# UNITED STATES PATENT AND TRADEMARK OFFICE

APPLICATION NO.	FILING DATE	FIRST NAMED INVENTOR	ATTORNEY DOCKET NO.	CONFIRMATION NO.
10/525,304	02/23/2005	Xin Wei Gao	FYC 05-1-1	6016
23531	7590	10/18/2006	EXAMINER	
SUITER WEST SWANTZ PC LLO 14301 FNB PARKWAY SUITE 220 OMAHA, NE 68154			HAWK, NOAH CHANDLER	
			ART UNIT	PAPER NUMBER
			3636

<b>Office Action Summary</b>	<b>Application No.</b>	<b>Applicant(s)</b>	
	10/525,304	GAO, XIN WEI	
	<b>Examiner</b>	<b>Art Unit</b>	
	Noah C. Hawk	3636

## **DETAILED ACTION**

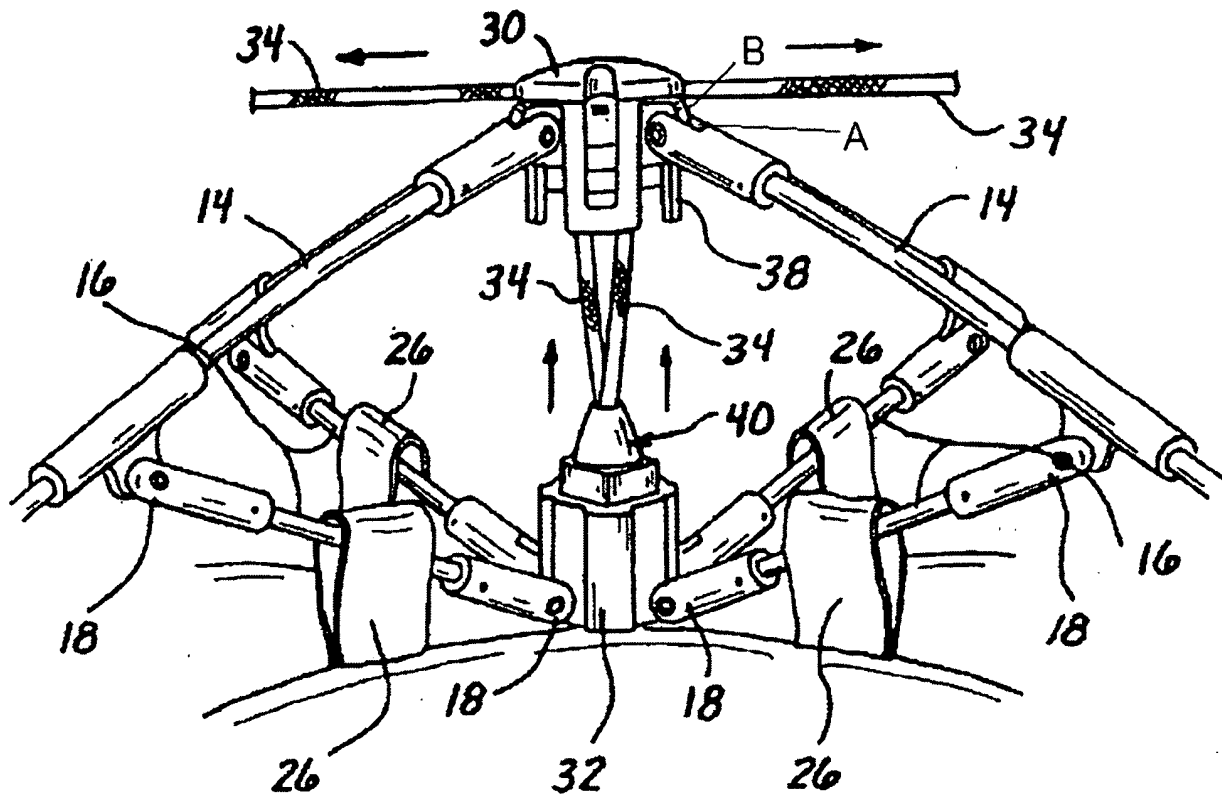
a. Regarding Claim 1, Chai teaches a tent including a frame and a canvas (22) which covers a periphery of the tent frame, the tent frame including an umbrella type frame (Best seen in Chai, Figures 6 and 7) with an upper central head (38) and ribs (14) hinged thereto and a spreader frame (Best seen in Chai, Figure 6) with a lower central head (32) and spreaders (16) hinged at one end to the lower central head and at the other end to the ribs. Chai also teaches two

cords (34) but fails to teach movable blocks in the lower head. Smith teaches an umbrella-type tent with upper (39) and lower (45) central heads having a cord (37) attached at one end (42) to the upper central head, extending around a movable block (48) in the lower head and extending through an opening (41) on the upper central head to the outside. It would have been obvious to one of ordinary skill in the art at the time of invention to use the cord arrangement taught by Smith on the two cords taught by Chai in order to provide a more easily assembled tent.

Chai '476, Figure 6

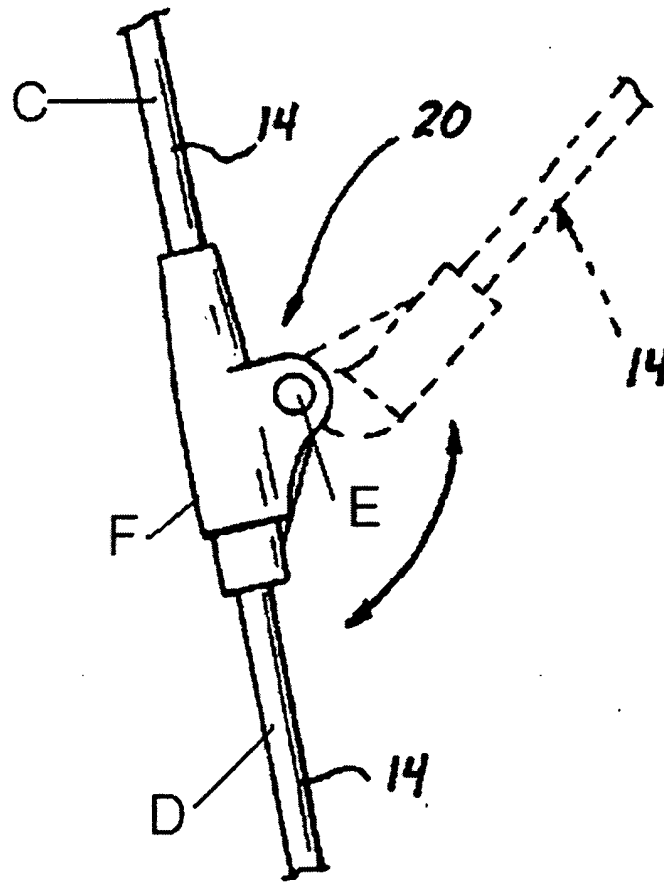
c. Regarding Claims 3 and 8, Chai, as modified, teaches that the upper central head includes a base (38) and a cap (30), the base including racks (A) which are closely coupled with grooves (B) at inner surfaces of the connectors and a protrusion (40) is formed on the lower central head for inserting into an opening in the base of the upper central head (Best seen in Chai, Figures 6 and 7).
